DOCKETED	
Docket Number:	24-OPT-03
Project Title:	Soda Mountain Solar
TN #:	261255
Document Title:	Christina Aiello Comments - Impacts to desert bighorn sheep
Description:	N/A
Filer:	System
Organization:	Christina Aiello
Submitter Role:	Public
Submission Date:	1/23/2025 10:54:32 AM
Docketed Date:	1/23/2025

Impacts to desert bighorn sheep

Re: Soda Mountain Solar Docket #: 24-OPT-03 Potential Impacts to Biological Resources

Potential impacts of the proposed Soda Mountain Solar development on desert bighorn sheep

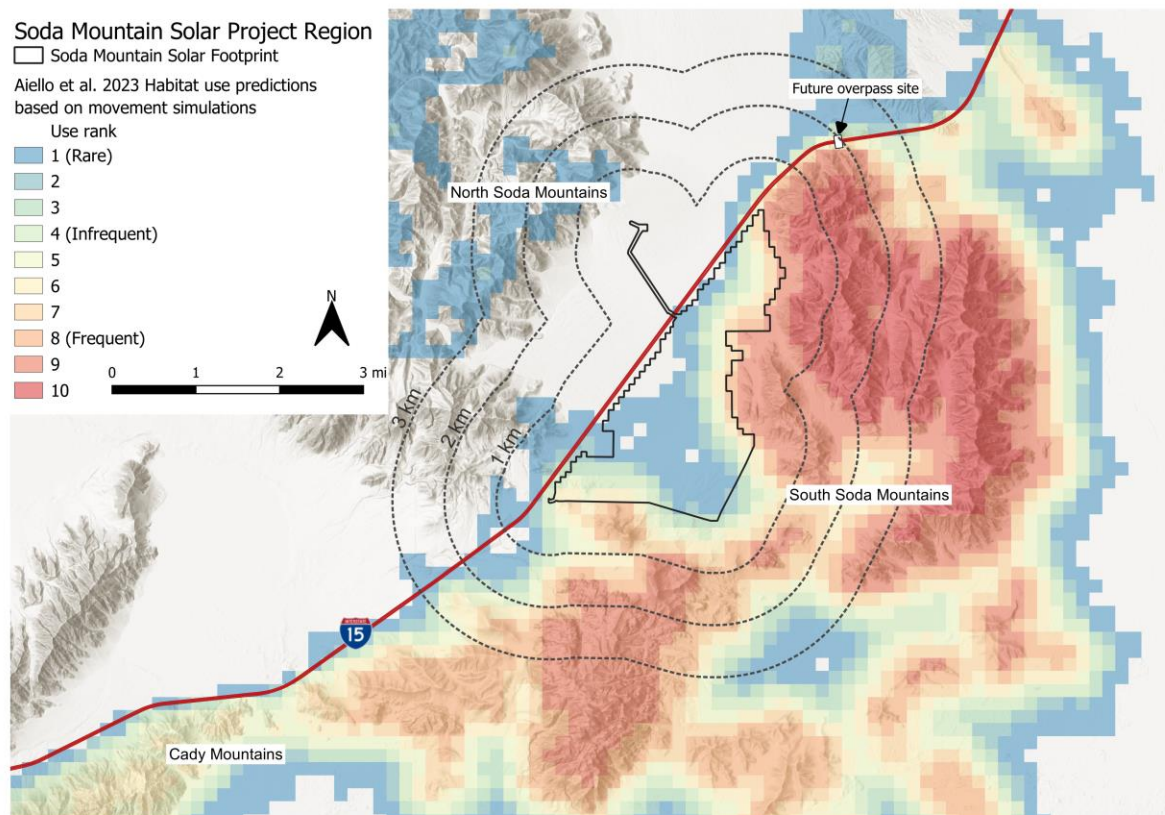
The simulations classified areas within the proposed solar footprint as reachable habitat that is used with varied frequency. The footprint overlaps with 2,432 acres of habitat used during simulated movements (1.42% of the 171,188 acres used during simulations), with most areas used rarely to infrequently (Table 1). Documented use of these areas by bighorn have primarily occurred in winter when annuals first emerge at low elevations (Dudek 2024). These early-season forage sites comprise a valuable food and water source, particularly for females, as access to quality forage can influence early lamb survival (Wehausen 2005). Though this type of habitat may only be visited infrequently and comprises a small percentage of total habitat, it plays an important role in population performance. The south Soda Mountains are considered a range of marginal habitat quality (Weaver and Mensch 1970) and its low elevation and small size limit the timing and area of suitable forage; reducing access to any of these areas could have important effects on herd fitness and reproduction.

- Increased risk of local extinction of the Soda Mountain population: The project directly removes accessible habitat for this population (Figure 5, Table 1), but if it also disrupts movement to the Cadys, it could further reduce accessible habitat as well as gene flow and future immigration (Epps et al. 2005; Aiello et al. 2023). The population would have fewer resources within an already low-quality habitat patch, a reduced rate of immigration to offset population losses, and a reduced rate of future recolonization.

Figure 6. Predicted bighorn habitat use ranks (as described in Figure 5) subset to only include cells that had a view of at least 25% of the solar array based on a visibility analysis (Appendix A).

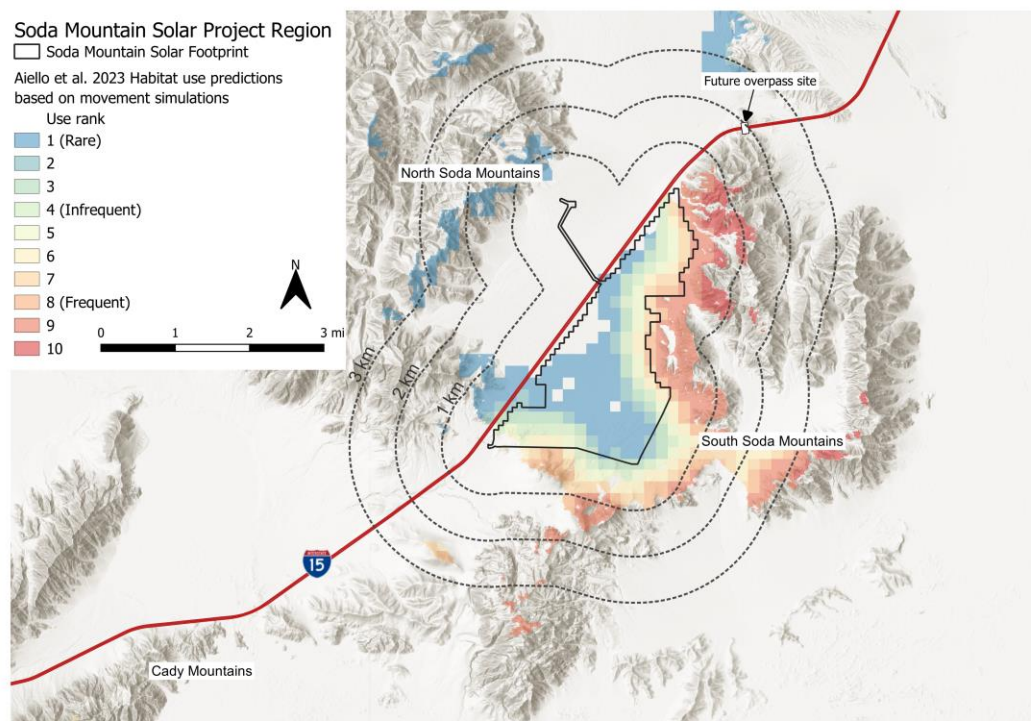
To identify areas at risk of visually-triggered impacts, we adjusted the total area of habitat within each buffer by cropping to areas that would have a clear view of at least 25% of the solar array (Figure 6; see Appendix A: Visibility Analysis for further details). Bighorn sheep behavior is shaped by the presence of risks and rewards on the landscape (Berger 1991, Bleich 1999, Papouchis et al. 2001, Dwyer 2004, Blum et al. 2023a, 2023b). Their keen eyesight and use of open habitat allows them to assess these factors at a distance to inform their movement decisions (Bleich 1999, Papouchis et al. 2001, Dwyer 2004, Berger et al. 2022). For example, in Sierra Nevada bighorn sheep, Berger et al. (2022) found evidence that a bighorn's decision to migrate to low-elevation winter range is partly informed by the habitat conditions that are visible from points used when on summer range. It is important to consider the potential effects of bighorn perception of these structures – if nearby animals perceive the facility as a risk, it could influence their decision to move toward the facility or adjacent areas.

In addition to directly overlapping areas of occasional use, we estimated that the facility would be partly visible from 2,217 acres of adjacent habitat frequently used by bighorn in the Soda Mountains, with 1,597 of those acres having a view of $\geq 50\%$ of the facility (Figure 8; Appendix A: Visibility analysis).

Figure 7. Soda mountain solar footprint relative to bighorn movement trajectories and predicted bighorn habitat from Aiello et al. (2023) and buffers around areas of 10% or greater slope of 0.25 miles (buffer recommended in Dudek 2024), 1 km and 2 km.

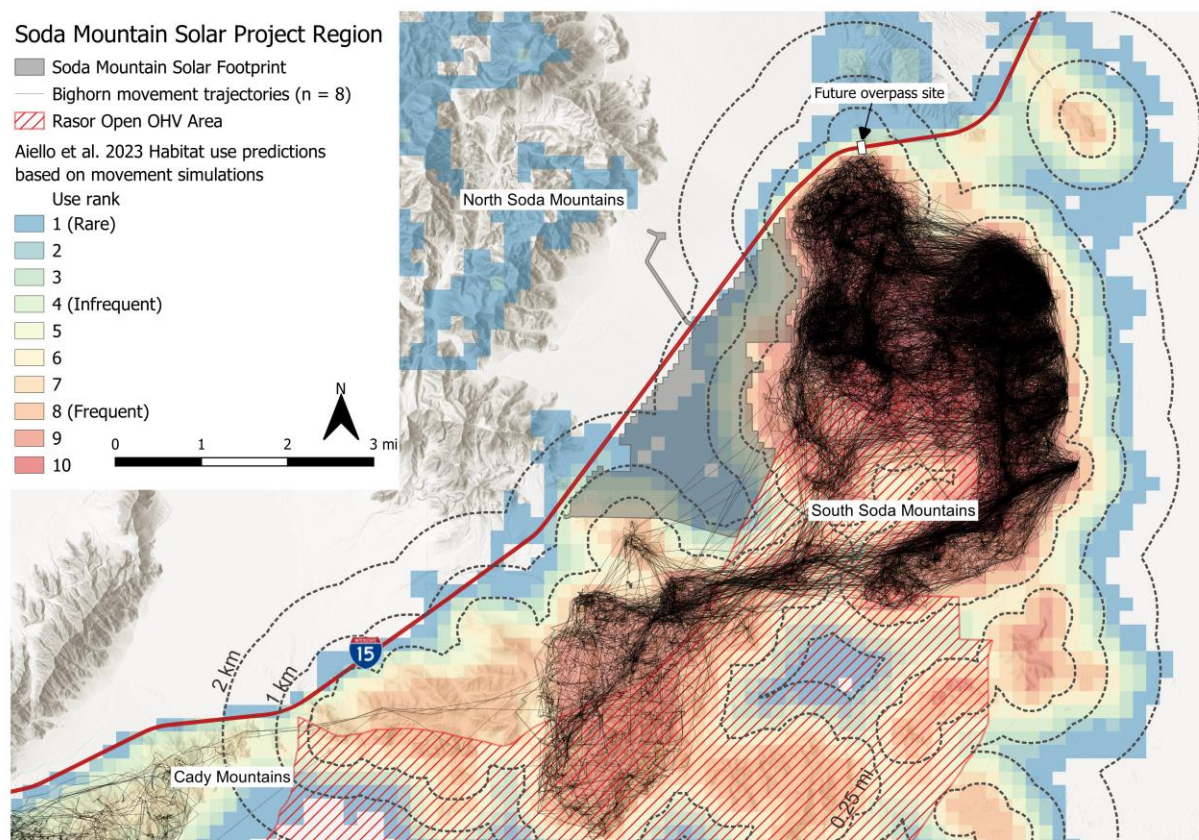
In light of the research and spatial data discussed here and in Dudek 2024, as well as the conservation benefits at risk, we believe the distance between this large-scale development and habitat used by desert bighorn is insufficient. Dudek's bighorn study submitted with the development application (Appendix D2) suggested a 0.25 mi buffer beyond the edge of areas with 10% slope based on past CDFW recommendations (mitigation measure MM-BIO-23, Project Footprint Setback). The project application *Section 3.4 Biological Resources* notably does not include this recommended mitigation measure in the list of proposed mitigations (3.4.5 Mitigation Measures). We believe the proposed mitigation measures are inadequate to reduce the project impacts to "less than significant", particularly when considering the potential for the project to *interfere substantially with the movement of any native resident or migratory fish or wildlife species or with established native resident or migratory wildlife corridors*. Further, based on the information provided in this assessment, we believe the recommended 0.25 mile buffer should be further extended to at least 1 km (0.62 mi), and ideally to 2 km (1.24 mi) to account for potential indirect effects and avoidance behaviors that may compromise essential bighorn movement corridors within this distance (see Figures 4-6).

Though a 0.25 mi buffer from 10% sloped habitat encompasses a majority of the habitat predicted as frequently used in Aiello et al. (2023), it does not protect intermittently used habitat (Figure 7). This buffer distance also does not provide protection from avoidance behaviors that may extend beyond the footprint up to distances observed in Sawyer et al. (2017, 2019, 2022). To reduce risk of the highest-impact scenario described above, a buffer distance between bighorn habitat and the project site would ideally be beyond the typical response distance of bighorn and other ungulates. Geist (1971) suggested that bighorn respond to predators at distances over 1 km away and so can likely process objects at this distance. We also found that most high quality habitat within view of the current footprint was within 1 km (Figure 6). Reducing the footprint so the project does not come within 1 km of 10% sloped areas would have the dual benefit of excluding structures from areas likely to receive intermittent bighorn use while providing a more robust buffer around movement corridors between Soda and Cave & Cady Mountains. It is unlikely that the structure would not be visible to bighorn at this distance, but perhaps would be far enough to reduce any perceived threats of activity associated with the development.

Creating a buffer between the facility and sloped habitat of 2 km, would be impossible within the project area, though there are reasons to support this measure for this and future USSE facilities. The

movement analysis in Aiello et al. (2023) as well as extensive observations and research on desert bighorn in Southern California (Bleich et al. 1990; Epps et al. 2007; Creech et al. 2014; Dekelaita et al. 2023) indicate that desert bighorn are willing to use and cross flat areas that extend several km beyond 10% sloped terrain. In the Soda Mountains, it is clear that the preferred travel routes follow sloped terrain, but they are not the only routes that bighorn likely use. The presence of an active OHV area in the southern end of the range may already be constraining bighorn movement across other potentially suitable paths, or restricting movement to certain times of day or periods of the year. There has not been direct study of the effects of the OHV area on bighorn movement to assess existing impacts to this population, or how any future changes in OHV use (e.g., if OHV activity increases) may alter bighorn movement. If Soda Mountain Solar were built as proposed, bighorn travel options would be further constrained – with disturbance present on both sides of a vital movement corridor. For the future overpass effort to succeed and effectively reduce the long-term impacts of habitat fragmentation, this movement corridor must remain intact. Adding an additional development to an area already altered by OHV activity, a major highway, and a future high speed rail line seems like a reckless test of whether there is in fact a threshold level of disturbance needed before ungulates will abandon suitable habitat as suggested in Sawyer et al (2019). It is also counter-productive to the financial and time investments currently committed to increase habitat availability with the designed and planned overpass.
